Addendum #2 - Issued on October 19, 2011

Regarding Bids for The Source Roof HVAC Upgrades (**ITB 11-018P**) for the Lucas County Commissioners, bid opening scheduled for October 27, 2011 at 2:00 pm (local time).

ADDENDUM NO. 2

The Source HVAC Upgrade

A1.01 – 1st and 2nd Floor Occupancy Plan (New Sheet)

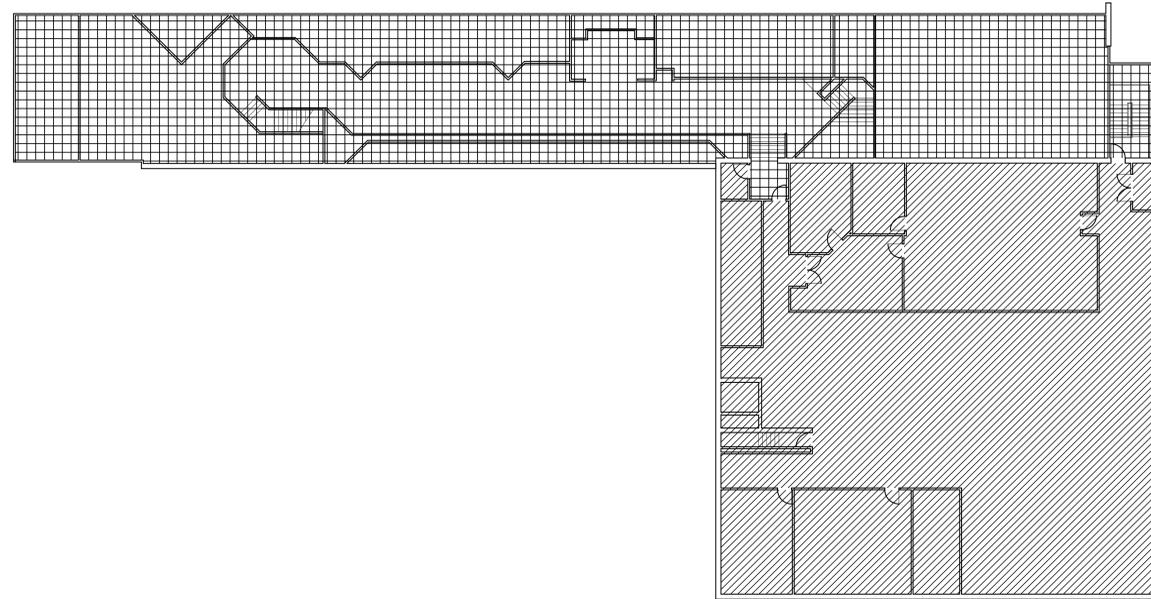
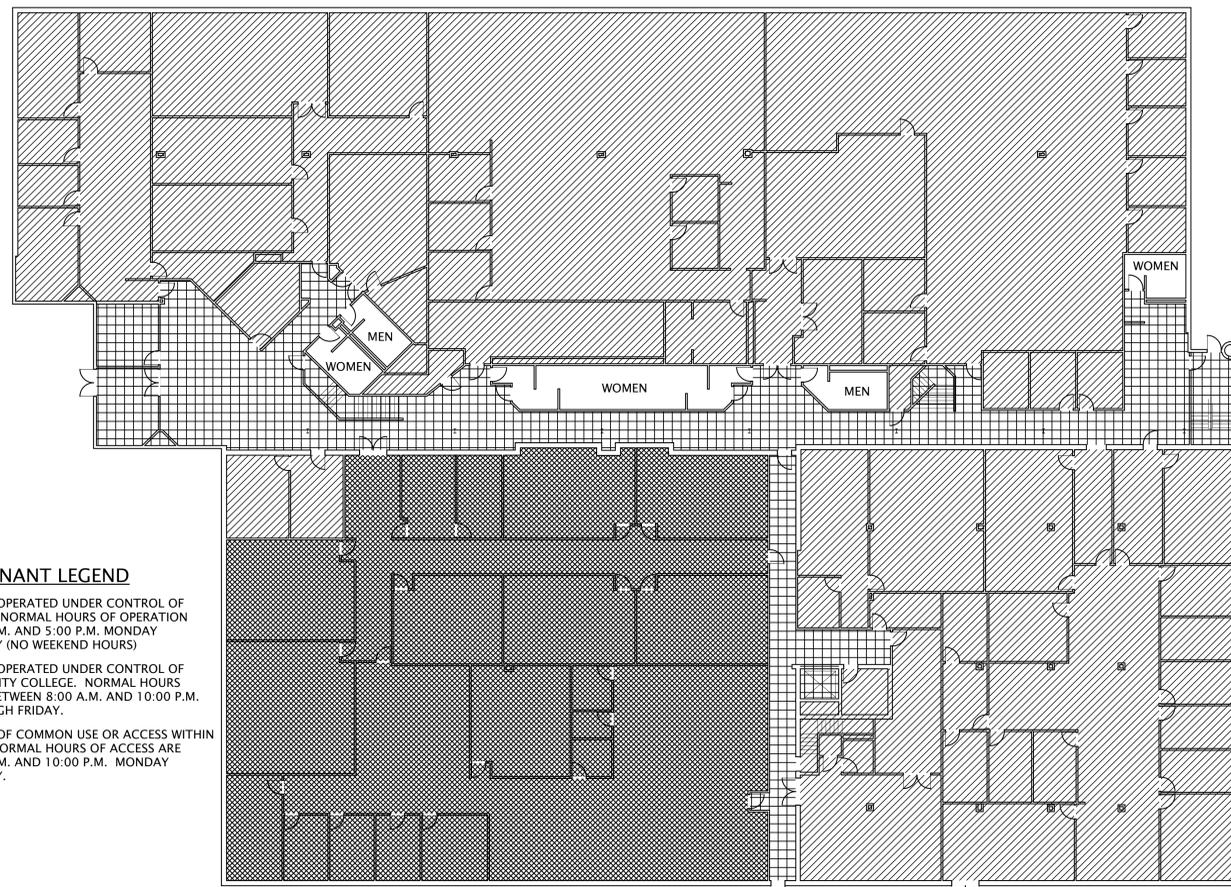
- Occupancy plan of 1st and 2nd floor indicating tenant controlled areas, areas of common access and normal hours of business operations for each tenant.

M2.0 – MECHANICAL SCHEDULES AND DETAILS (Re-Issued)

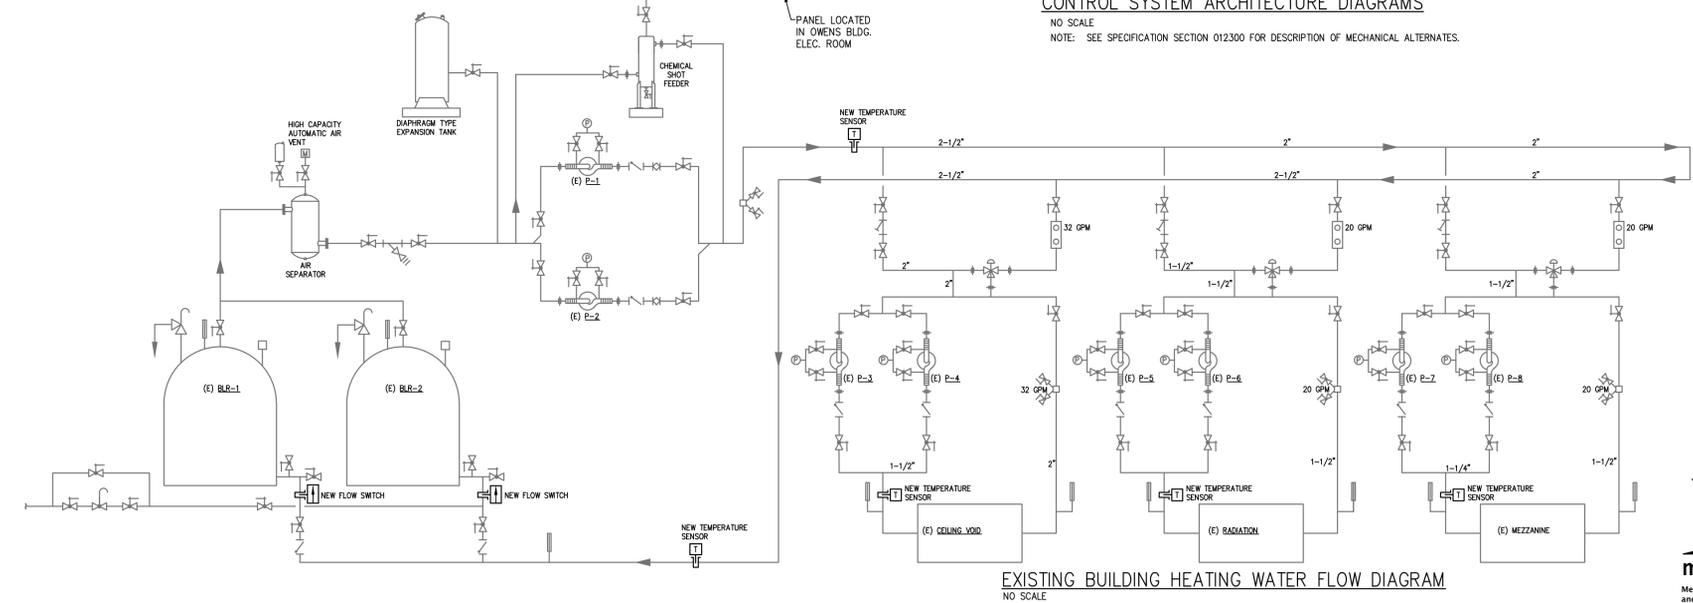
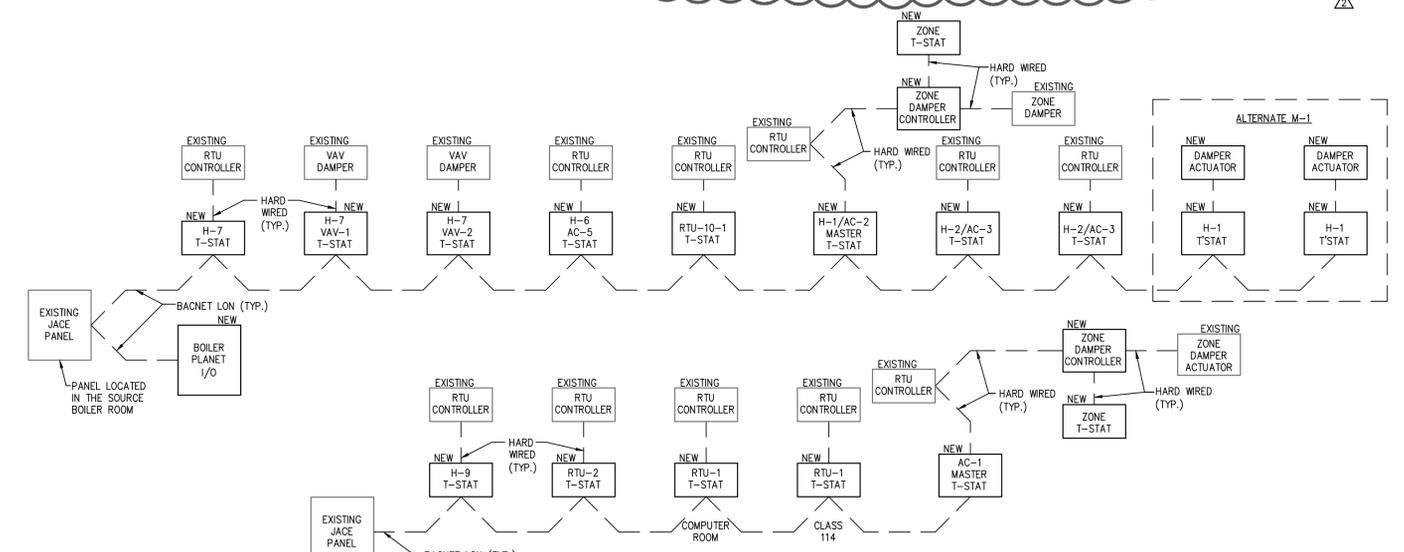
- Corrected misaligned text located within the “General (Mechanical) Notes”.
